The Krystal Company is amending their request for a variance for their restaurant location at 271 Cobb Parkway South. The original request was to retain their existing nonconforming sign that is approximately 40 feet in height and 210 square feet in area. The revised request is to be allowed to construct a new monument sign that would be 22'8" in height, and approximately 122 square feet in area for the sign face and 175 square feet for the sign structure. Current regulations would require the new sign to be a monument sign at a maximum height of 15 feet with a maximum area of 90 square feet for the sign face and a maximum area of 90 square feet for the sign structure.

Application #: V2016-40 Registrar #: 20160668 BZA Hearing Dt:
City Council Hearing Dt (if applicable) #: 8-10-16 PZ #: 16-375

Re: Variance for Krystal Burger

KRYSTAL V, LLC
KRYSTAL COBB PARKWAY DEVELOPMENT PLAN
SITE PLAN

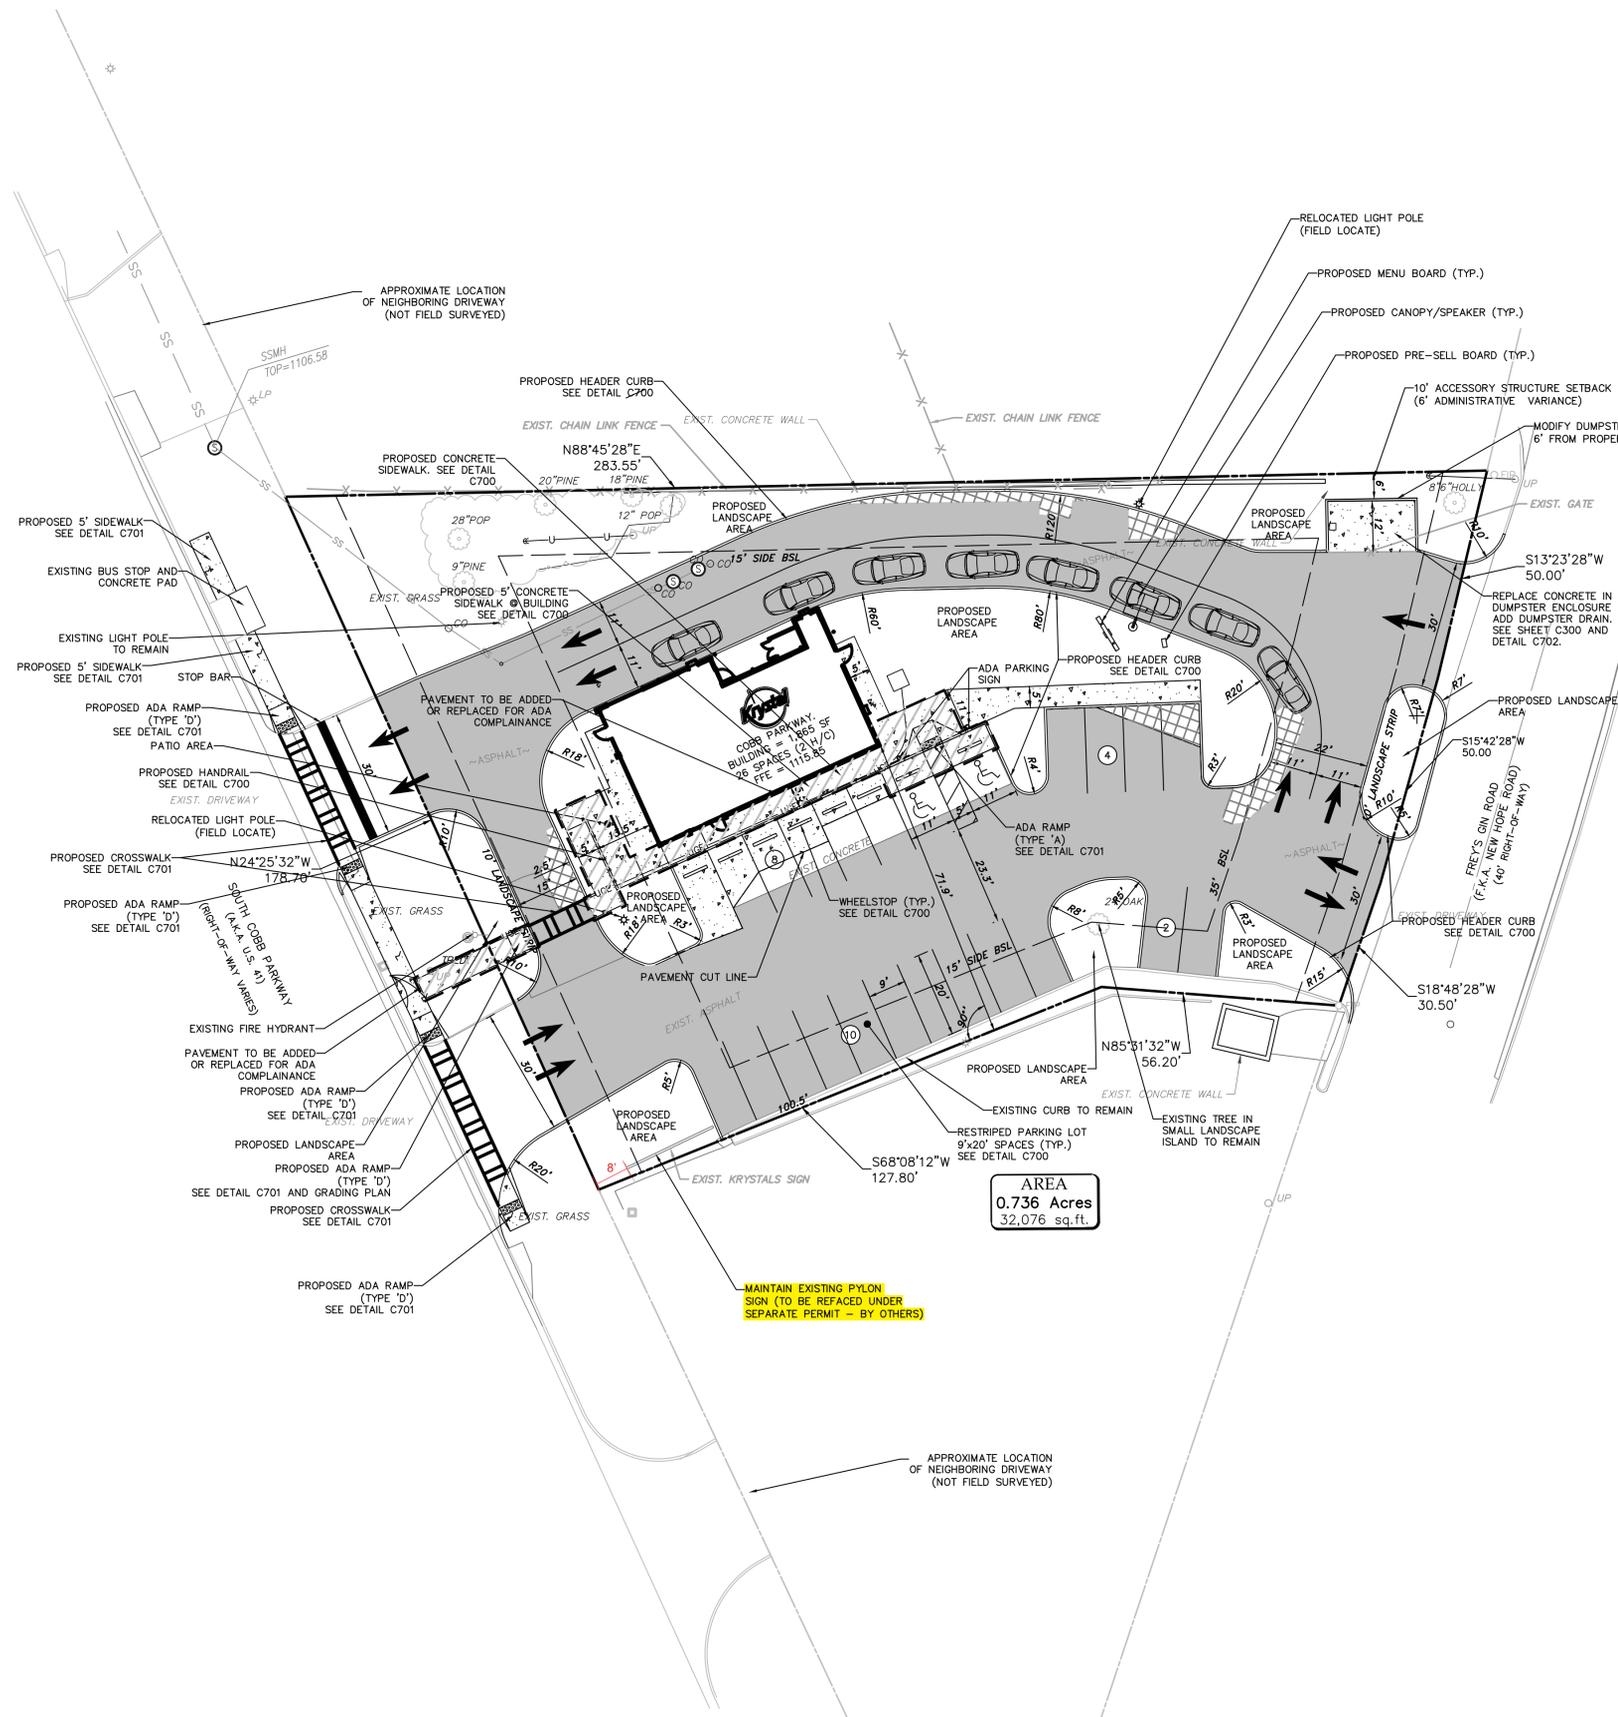
I would like to see this ugly sign removed.

If you want an example of a good looking fast food redevelopment, look at any of the new Zaxby stores. They look like old farmhouses with low signage that meets the city code.

Proposed Krystal sign

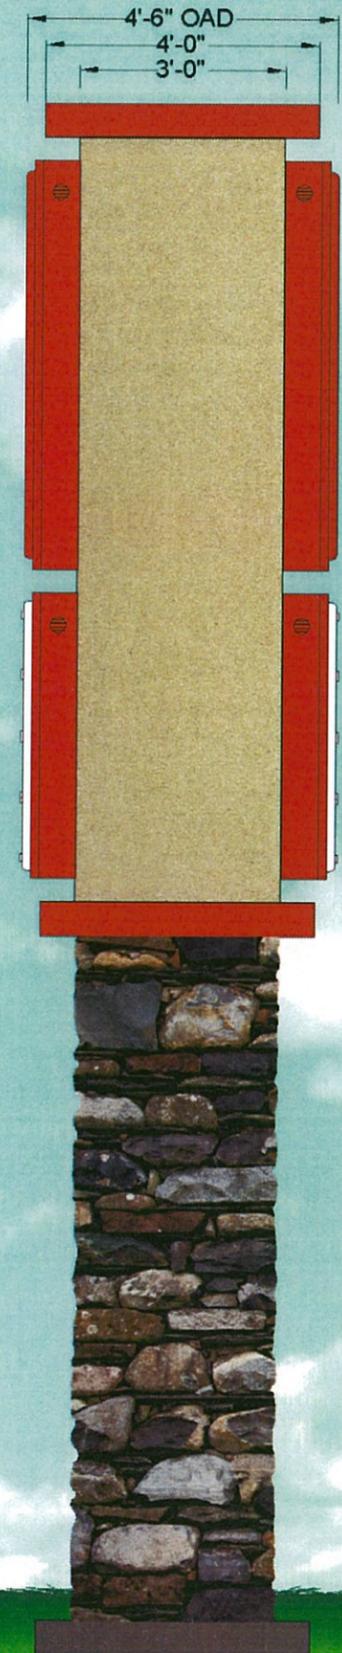
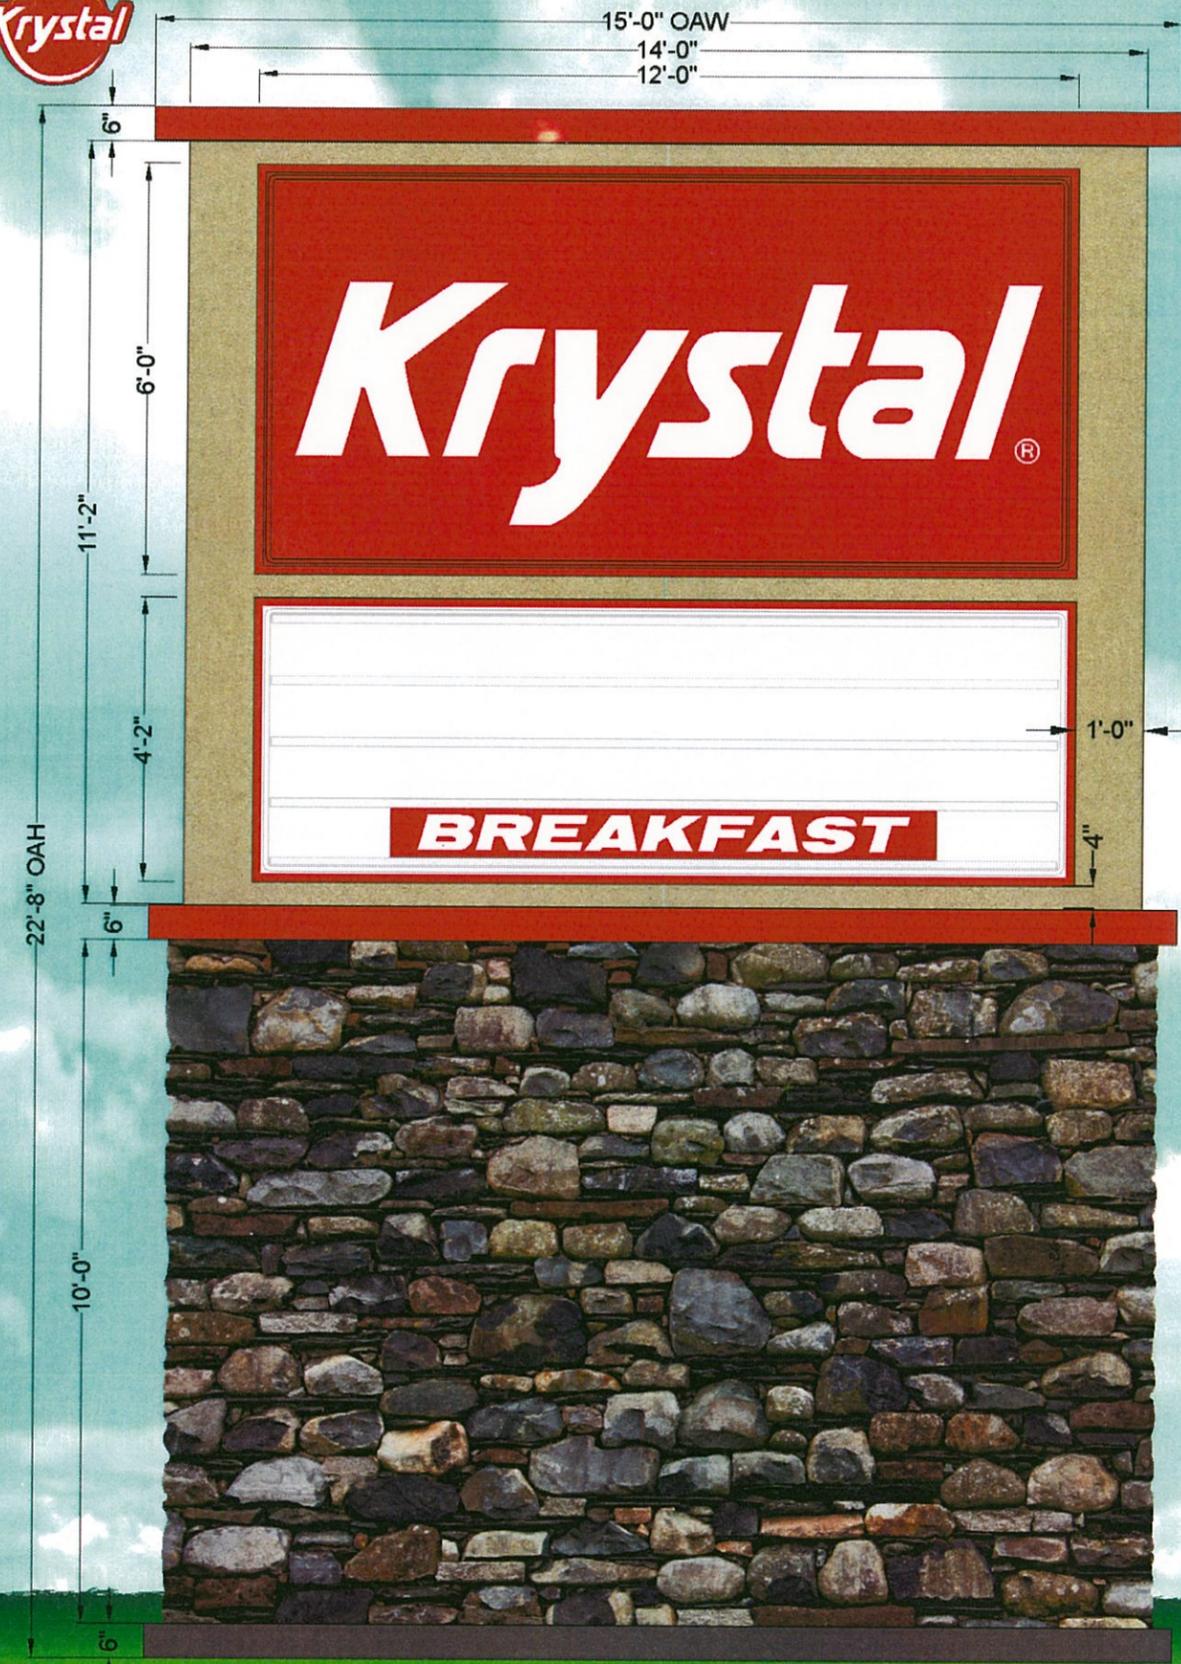
The Krystal Company is planning to demolish the existing restaurant building and build a new restaurant on the subject property. However, the applicant states that they would be at a “competitive disadvantage” if they had to build a sign that would meet the current ordinance. The only other nonconforming sign near the Krystal location is the sign for Krispy Kreme donuts. The applicant has pointed out that Krispy Kreme recently renovated their property and kept their existing sign. However, Krispy Kreme chose to do minor renovations (less than 50% of the buildings replacement costs) so that their sign would retain its nonconforming or “grandfathered” status. This option is also available to The Krystal Company.

In addition, most new businesses choose to comply with the City’s regulations. If the variances requested by Krystal were to be approved, then those businesses would be at a disadvantage because they complied with the sign regulations, and thereby helped to reduce sign clutter and make the City more attractive. For example, when Popeye’s and Arby’s (at 155 Cobb Parkway South) were constructed in 2008, they worked with the City to reduce two nonconforming signs along Cobb Parkway when they redeveloped their entire sites. Those businesses removed a large billboard at their own expense, and then shared signage so that there is only one sign between the two restaurants.

Section 714.06 (C.6) of the Zoning Ordinance states that *“In cases where there are existing nonconforming signs on a parcel in which there will be a renovation of the primary structure exceeding 50% of its replacement cost or there is redevelopment of a vacant lot, the entire sign (in each case) shall be required to come into compliance with the City of Marietta Sign Ordinance.”* These regulations were put in place to allow nonconforming signs to continue to be used until substantial redevelopment of the property occurred, with the expectation that new signage would meet current regulations.
